CORABELLA

NWC. RPT. 97392

SKETCH "C"

Gudgeon Bush & Line on Rudder Pintle

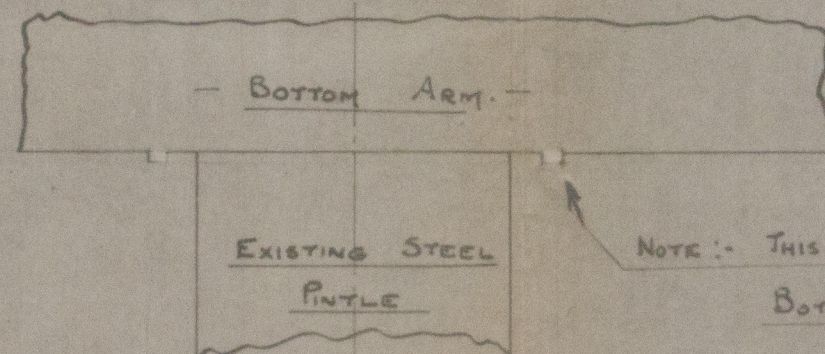
PROPOSED NEW BUSHES ON BOTTOM PINLE,
AND IN STERN FRAME

NOTE :- THIS PORTION TO BE CHIPPED OFF
BOTTOM OF BOTTOM ARM TO
ALLOW FLANGE OF NEW BUSH
TO COME AGAINST ARM.
